From: [Chad Williams](#)
To: [Troy Crews](#); [Melissa Garber](#)
Subject: Re: Permit # 53327
Date: Wednesday, September 17, 2025 12:21:07 PM
Attachments: [image001.png](#)
[image002.png](#)
[image003.png](#)
[FOREST COVE CONST PLANS 5-10-23.pdf](#)

Lot 10 Forest Cove - permit # 53327

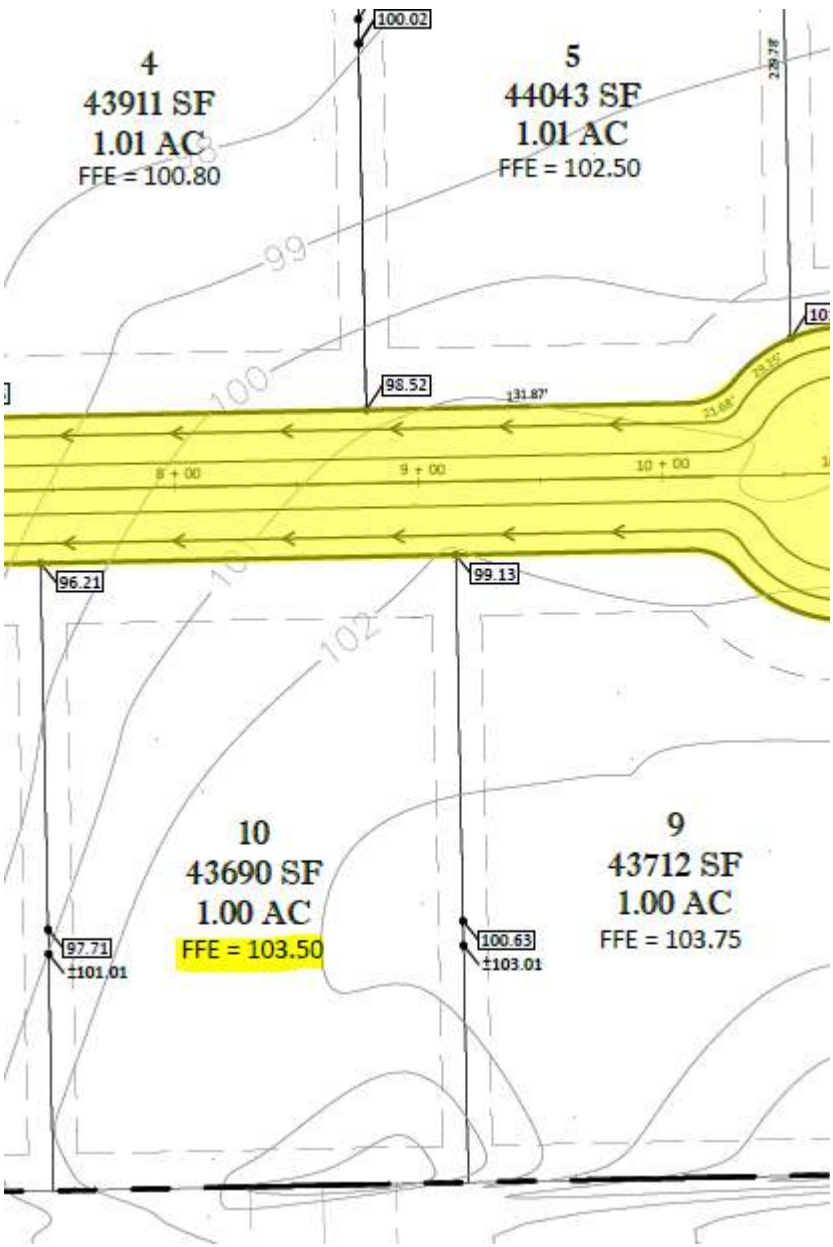
This asbuilt is OK as far as the finish lot grading and stormwater flows.

There is an issue with the finish floor elevation. The permitted/approved plans showed a finished floor elevation of 103.5 for lot 10. The submitted asbuilt shows the FFE at 102.8

Troy
They have submitted revised plans that match the below.
See attached. This asbuilt s OK.
Chad
